March 1, 2024

Re: Clawe response to Comments by **Thomas Trainor, 97 Washington Street, Sherborn MA**
Comments for ZBA on the proposed 40B Farm Road Homes: Septic Nitrogen (Nitrate) Loading, Threats to Groundwater and the Public Health.

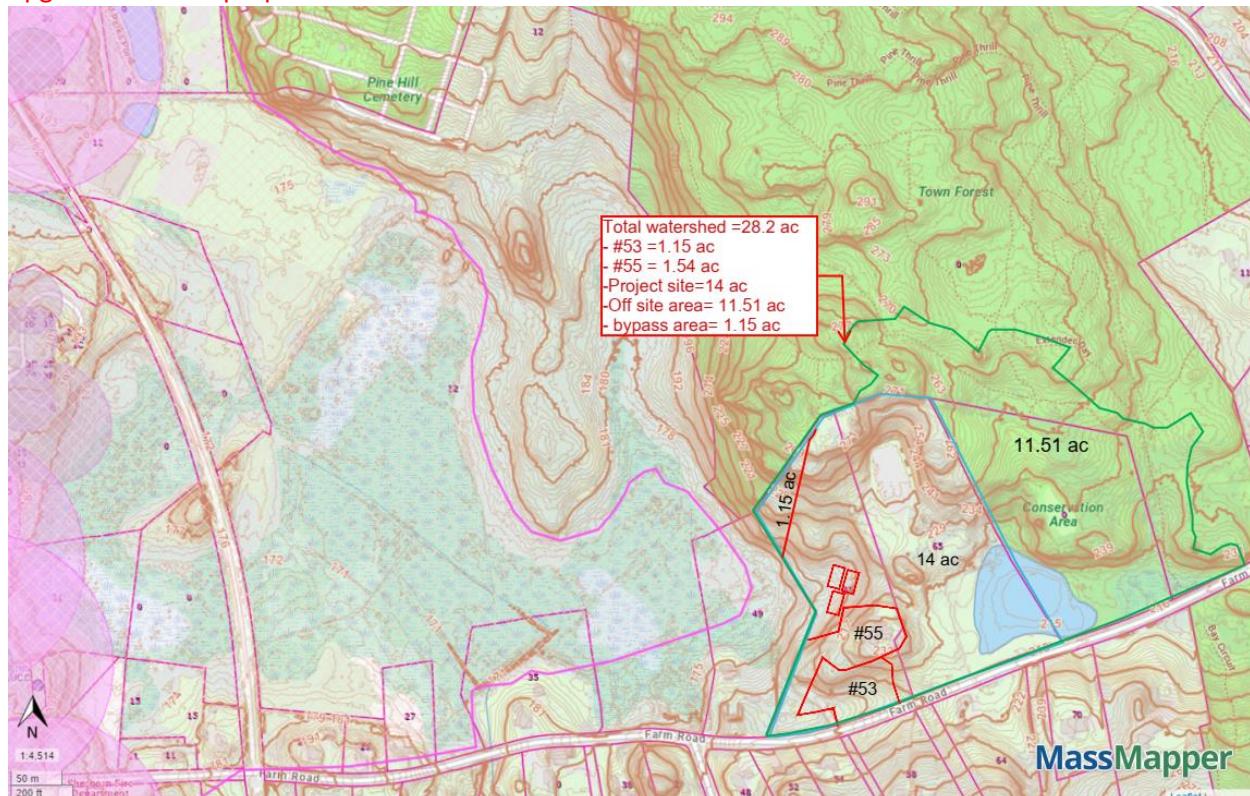
B. Nitrate Concentrations of Concern in Groundwater within Massachusetts.

The Sherborn BOH (for private wells) and the MassDEP (for public water supplies, PWS) regulations both list a MCL of 10 mg/L (or 10 ppm) for nitrate (NO₃, which you may also see labeled as "nitrate-nitrogen" or NO₃-N) for a concentration limit in potable drinking water. Please know that this 10 mg/L limit was first proposed in this country by the US EPA back in 1975 (five years after the agency was first formed), about 49 years ago. Two very informative and frequently cited documents covering the practical challenges and many concerns of nitrate in groundwater/drinking water, and surface water in MA are attached here:

Response: The project SAS is in compliance with the quoted section of Title 5 as it is located outside of all zones in 310 CMR 15.303(1)(c) see following detailed information.

1 – No water supplies or tributaries to a surface water supply are located within 400' of the proposed SAS.

2 – The following are the approximate distances from the proposed SAS to the closest zones:

Zone 1: 2523-ft

IWPA: 2205-ft

Zone II: 225-ft

Note: These distances are obtained via Mass Mapper
